Development Application **ACCESS REPORT**

Reference Number: 22435

Client: Core Project Group Pty Ltd.

Site Address: 75-77 Elgin Street, Maitland NSW

[Image description: Plan of Ground level above shows the provision of Accessible parking space]

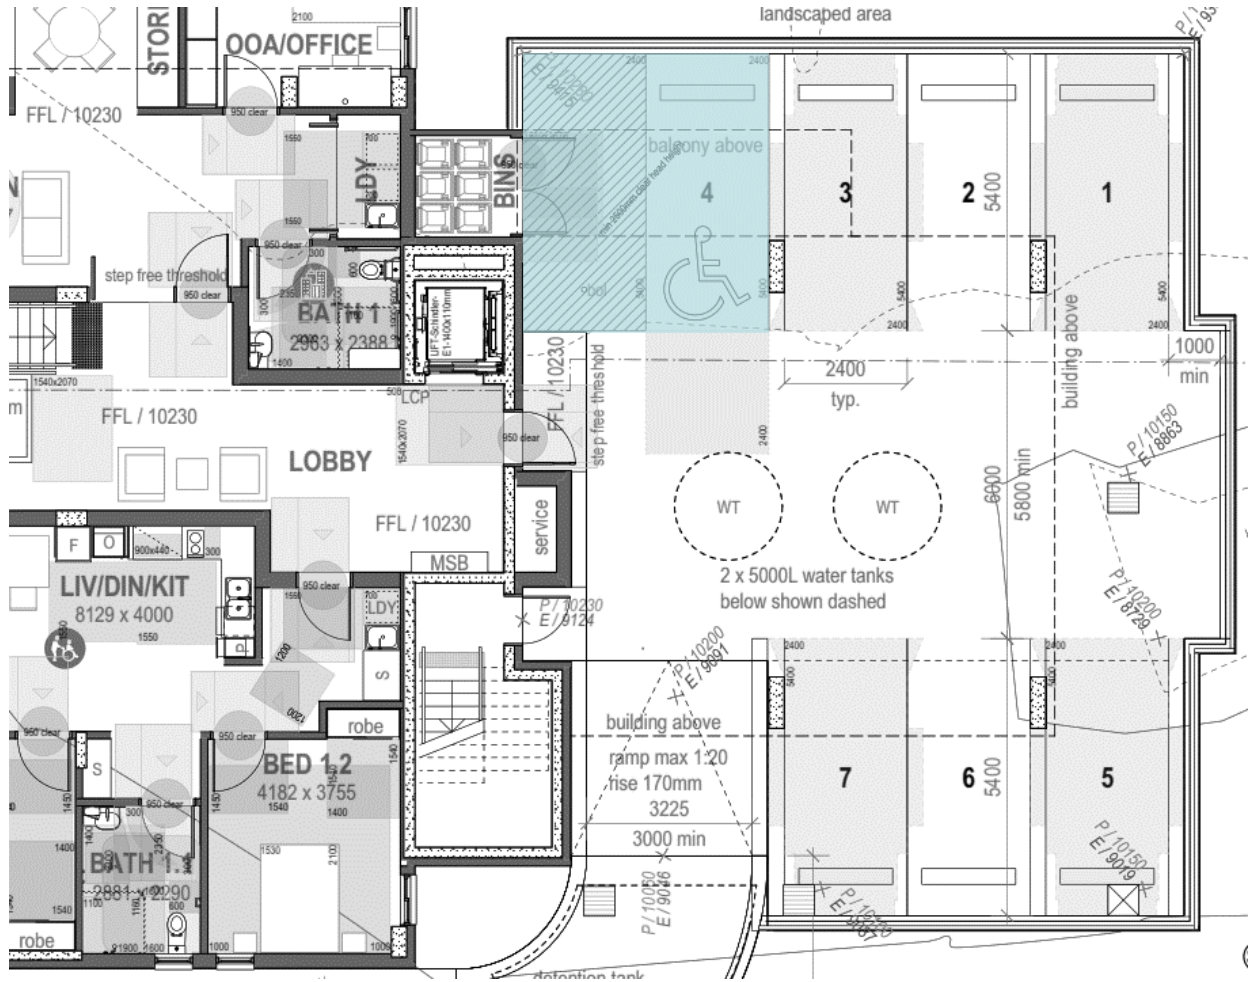
1 Accessible parking space has been provided as required.
